WÅTER WELL REPORT STATE OF OREGON

City of Portland Bureau of Water Works

RE: City of Fortland Production Well No. 14 - Phase IV Contract
Request for Special Standards

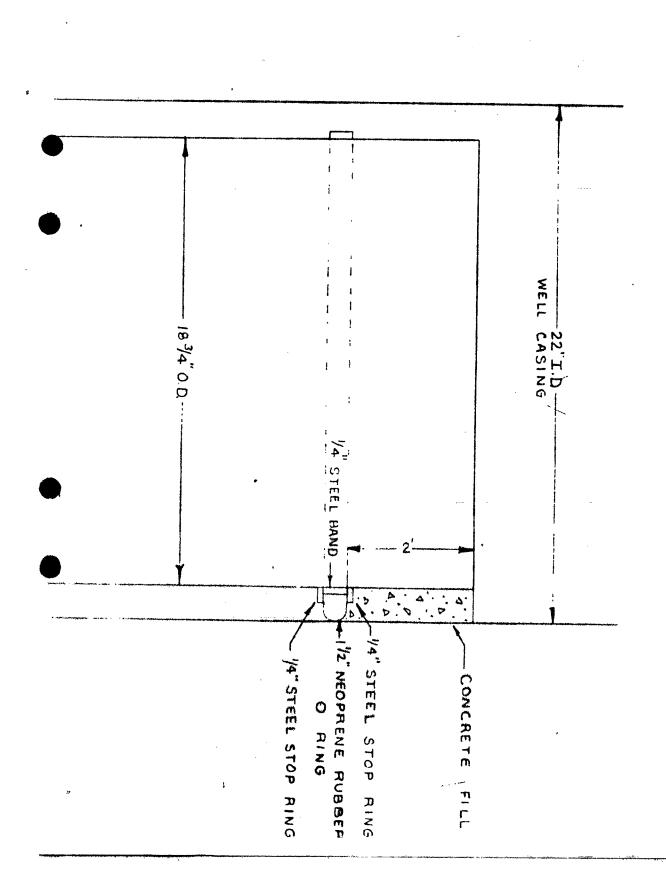
Enclosed is a drawing of a typical water tight seal used between the 18" and 22" casings on Type 1, Phase II production wells. We anticipate the use of a similar seal on the Type 1, Phase IV production wells.

To reiterate: 1) a 20-foot seal will be approved in the confining stratum overlying each confined water bearing zone; and 2) the neoprene/concrete seal between the inner and outer casings as shown in the drawing included with your May 7, 1982 request will be approved.
